Re: Phase I Bond Release, Deficiency Response (November 13, 2012), DOGM Permit C\015\032 Tast ID#4193

Deficiency List

East Mountain- Phase I Bond Release

Phase I Bond Release Application

DRAWN BY	PJ	SCALE	1" = 200'
APPROVED BY	JM	DATE	20 NOV. 2012
SHEET			MAP #1

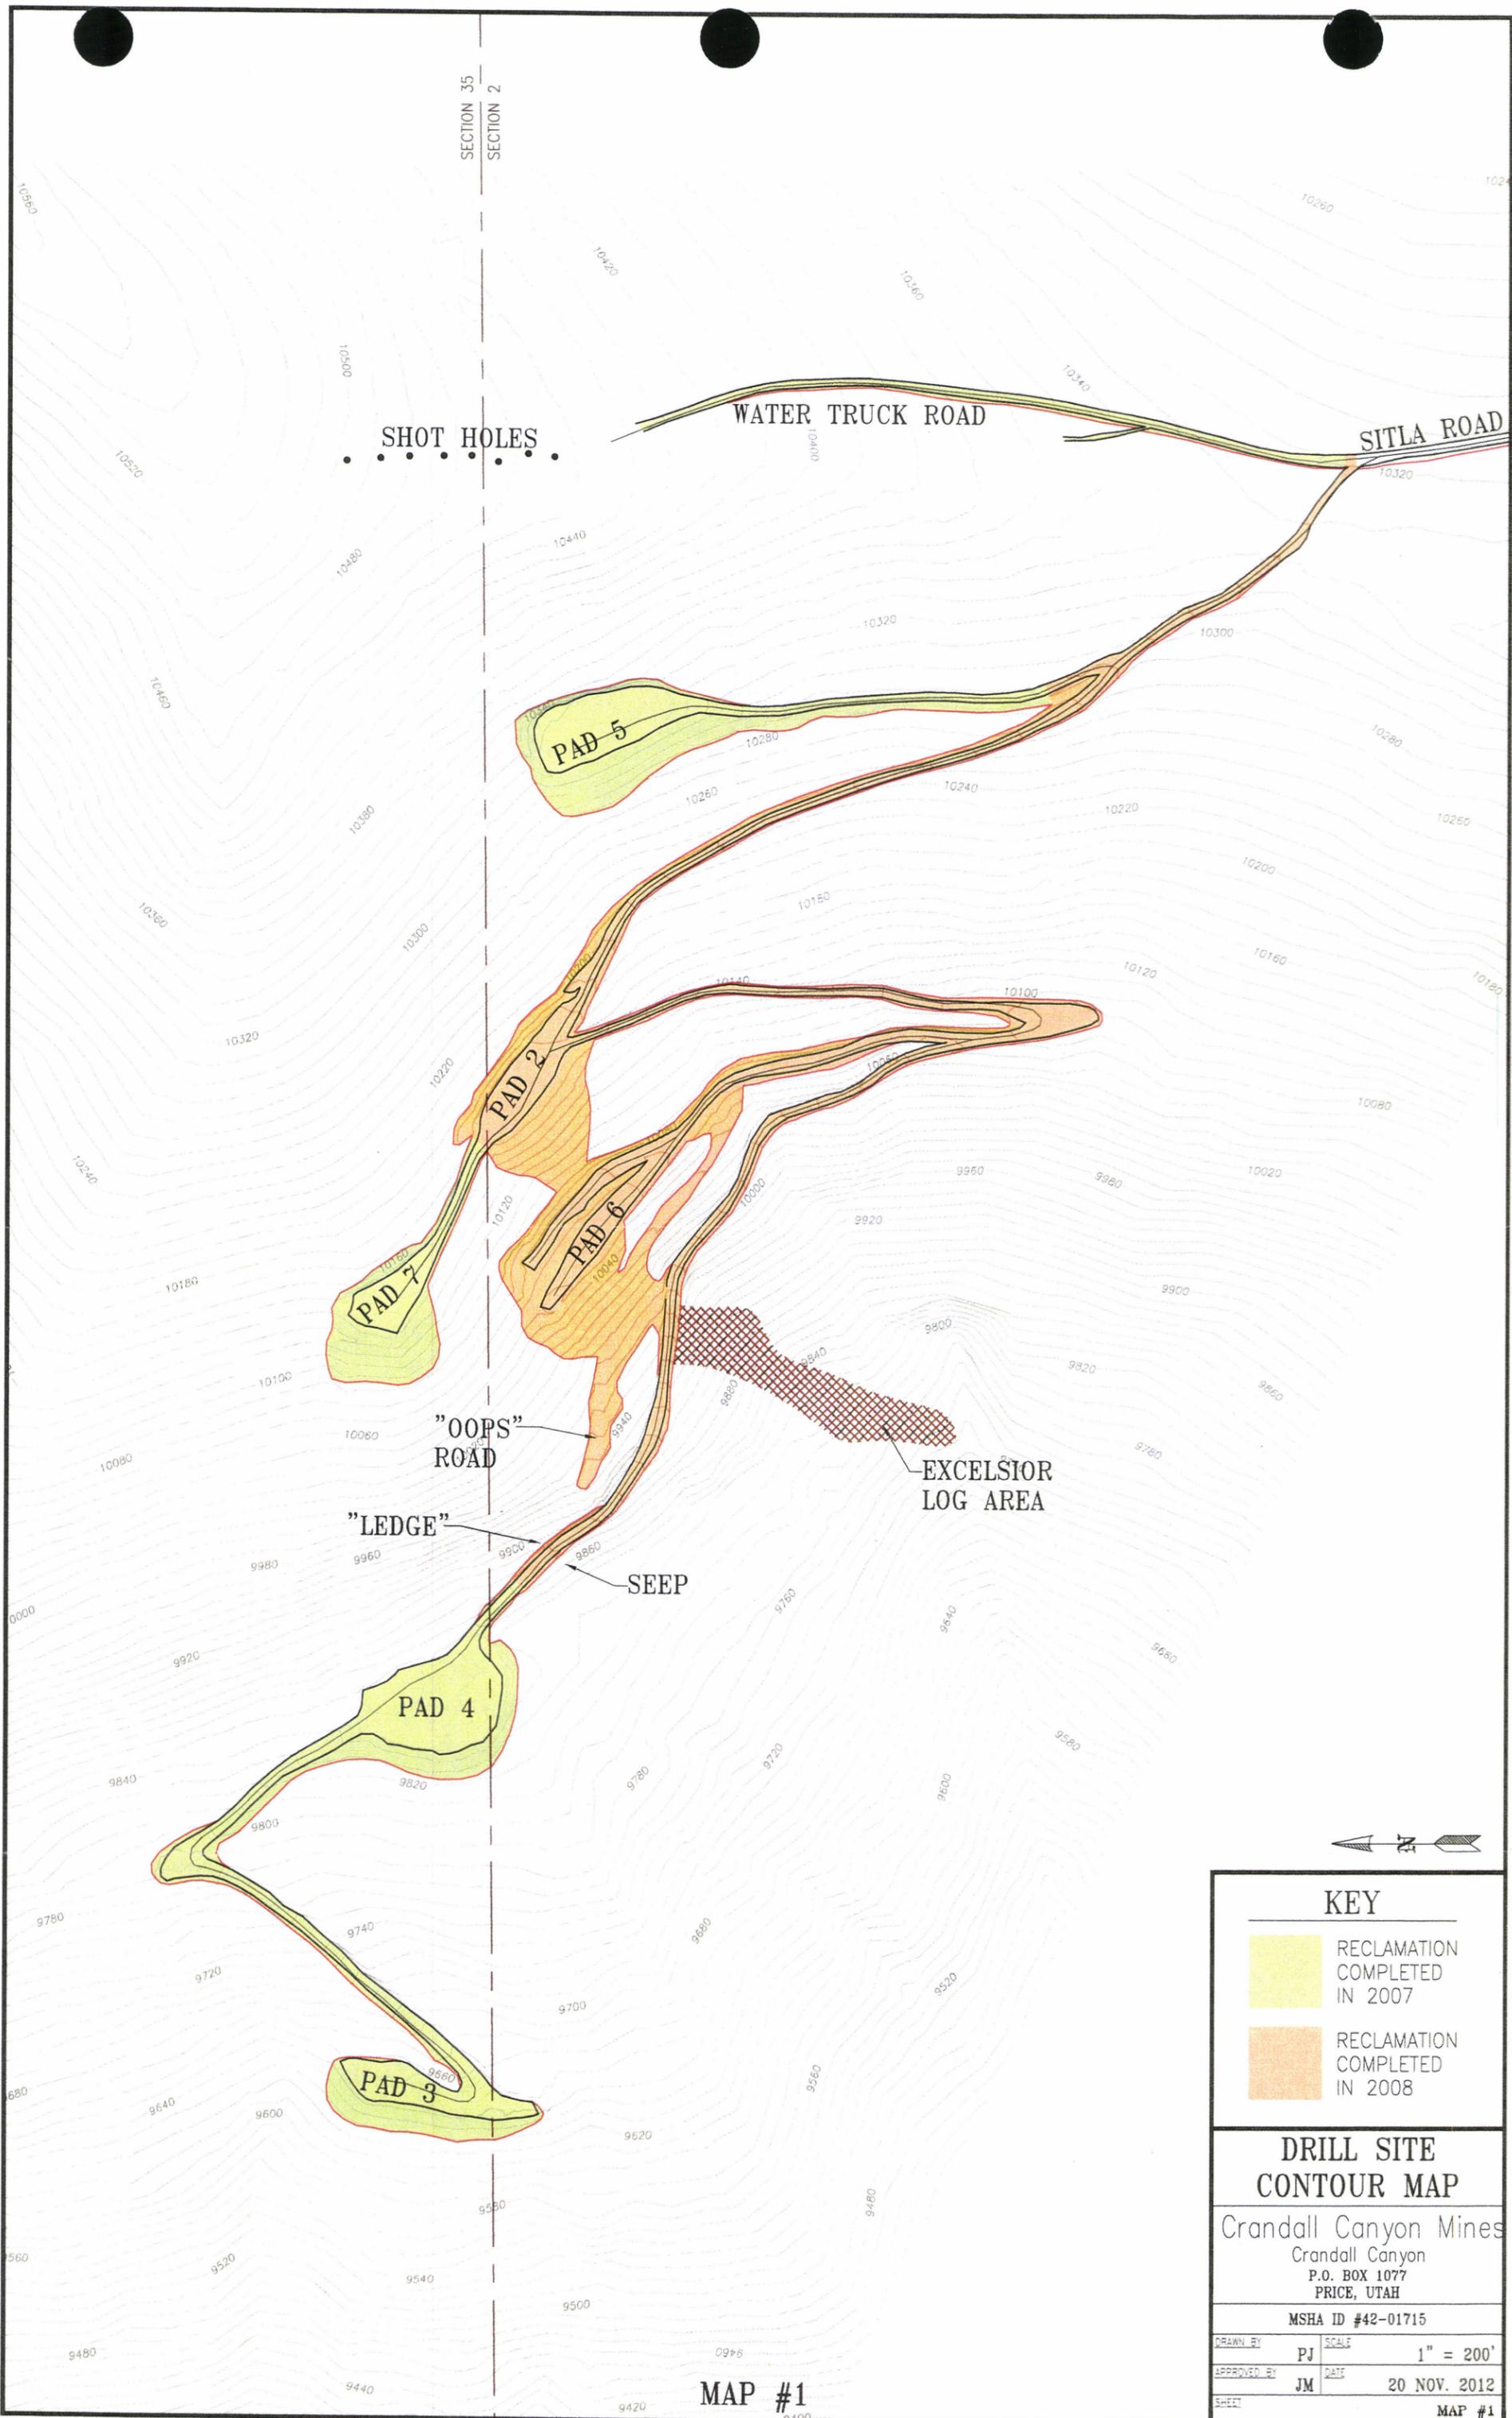
1) As built mapping should show the locations of excelsior log installation at the slide area on Map #1.

Map #1 has been revised to show the Excelsior log area.

REV: 12	ACAD: LEASE SOCRAN9
DATE: 11/20/12	BY: JDS
SCALE: 1"=2000'	PLATE #: 1-1

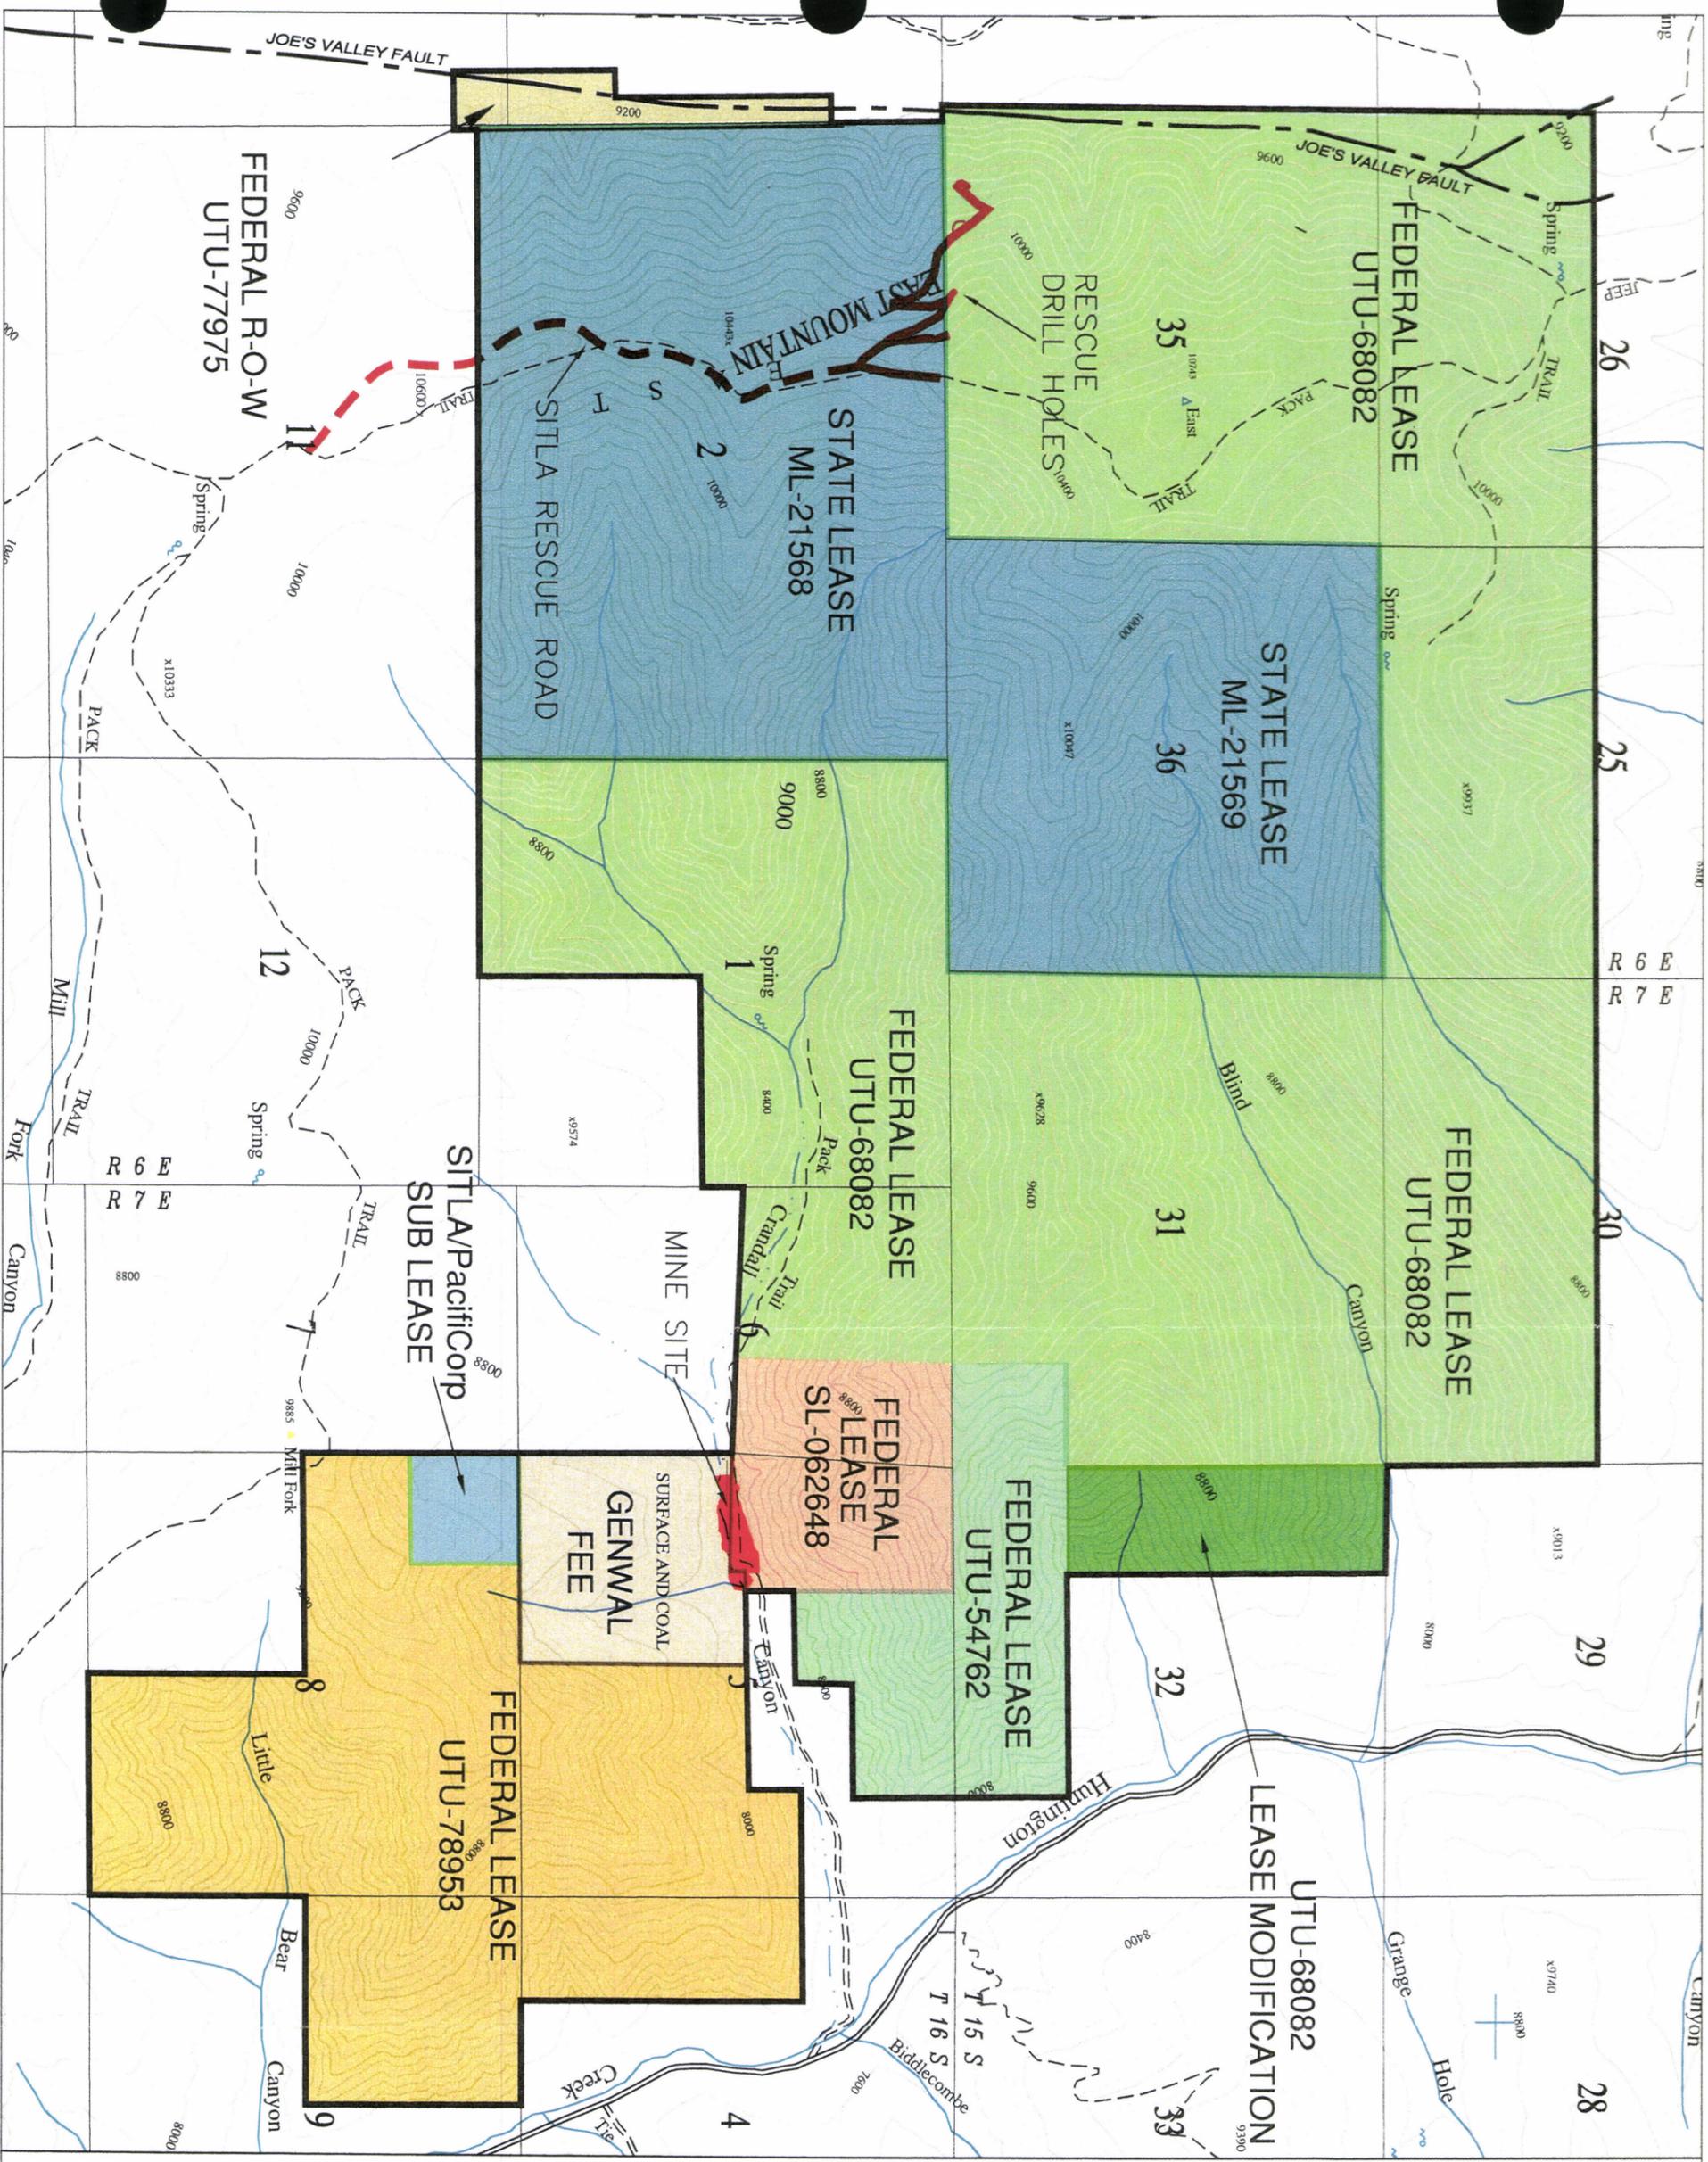
2) The application should either include or reference Plate 1-1 of the MRP to show the location of the disturbance within Township, Range and Section or label the section lines on Map #2 with this information.

Plate 1-1 has been included in the application.
